PROJECT TITLE EICC	
PROJECT NUMBER P2002877	SCALE 1:200@A1
DRAWING TITLE EICC LEVEL -2 PROPOSED GA PLAN	DATE 23/07/2009
REVISION (20)AP002	REVISION NE

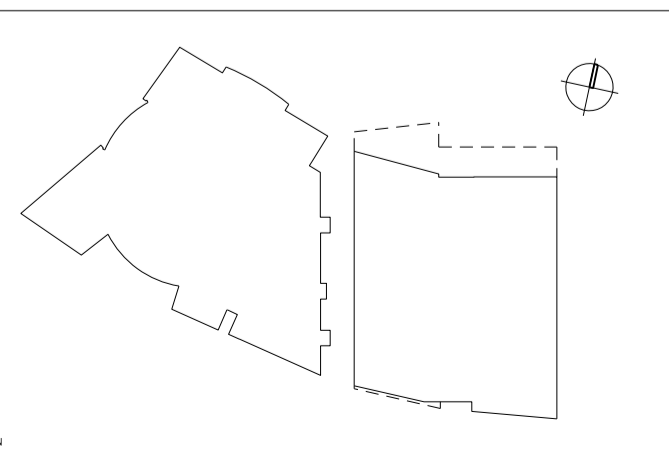
NE- CHAMPAGNE BAR ADDED AS INSTRUCTED.

ND- SOUTH MPH MOVING PARTITION STORE UPDATED TO SHOW SINGLE DOOR

NC- PARTITION AND SANITARY SET OUT UPDATED TO SUIT LIFT #11 BLOCKWORK REQUIREMENTS

ADJUSTMENTS TO RAMP/CORRIDOR IN EXISTING. REMOVAL OF PASS DOORS TO BAR.

NB- Extended HV switchroom revised layout updated.

NA - REVISION TO NORTH CORES TO PERMIT AN ALTERNATE MEANS OF FIRE FIGHTER ACCESS INTO THE MPH

N - Doors revised to meet requirements for minimum structural opening sizes. Adjacent walls adjusted to allow for extra width. Doors added to extended section. Concrete ribs removed from south retaining wall. Revised Zones B & E toilet layout. Steel columns changed to concrete.
